ZONING CHANGE REVIEW SHEET

CASE: C814-2018-0121 -- 218 South Lamar

Proposed Rezoning. The Applicant is requesting PUD zoning to allow redevelopment of the property with an office building with mixed pedestrian-oriented uses on the ground floor. In brief, the Applicant is requesting to:

4-Lane Divided, 60' Curb-to-Curb
Back-of-Curb Condition F
Barton Springs Road to Riverside Drive

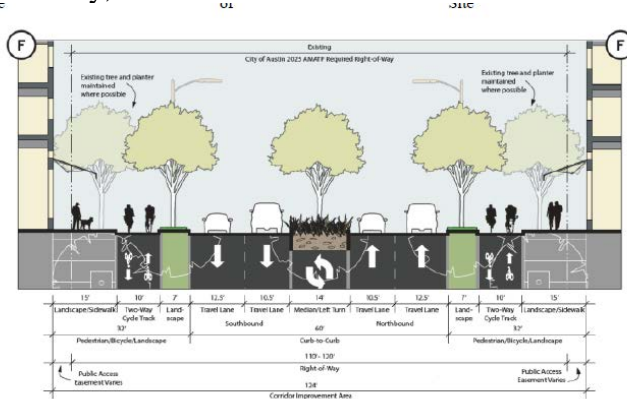
TR2. Include the below streetscape in the land use plan. Contact this reviewer for a more legible copy of it if necessary. This project is adjacent to a street that has been identified in Austin's Corridor Mobility Program (S Lamar). The sidewalk and bicycle facilities shall comply with the required cross-section at the time of the site plan application. The cross section that will be required is shown below. Find additional information about the Corridor Mobility Program here: <https://data.austintexas.gov/stories/s/Corridor-Mobility-Program/gukj-e8fh/>. Any proposed curb relocations on S Lamar requires coordination with the Corridor Planning Office and Bicycle Program. The cross section will include a 7' planting zone with street trees, a 10' two-way cycle track, and a 15' clear zone all behind curb. Additionally, a protected intersection will be required at Toomey, to be reviewed at the time of Site Plan.

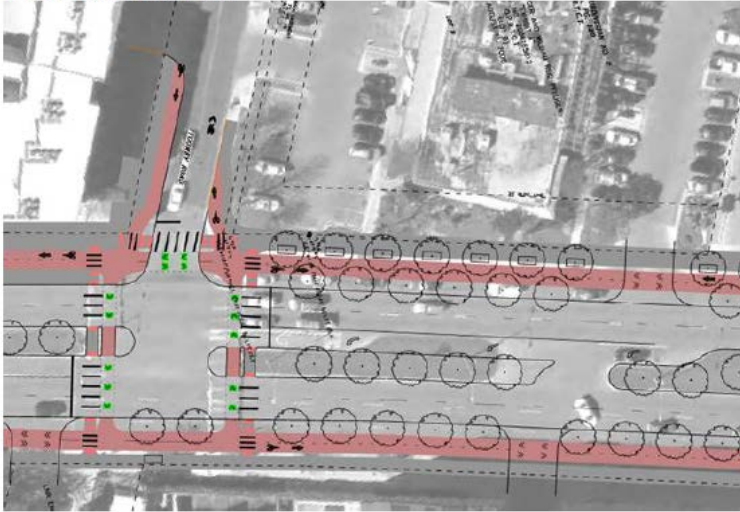
TR5. Bicycle facilities will be required along Toomey Road at the site plan stage. The design is below. Include the below graphic on the land use plan. If a more readable copy is required, contact this reviewer.
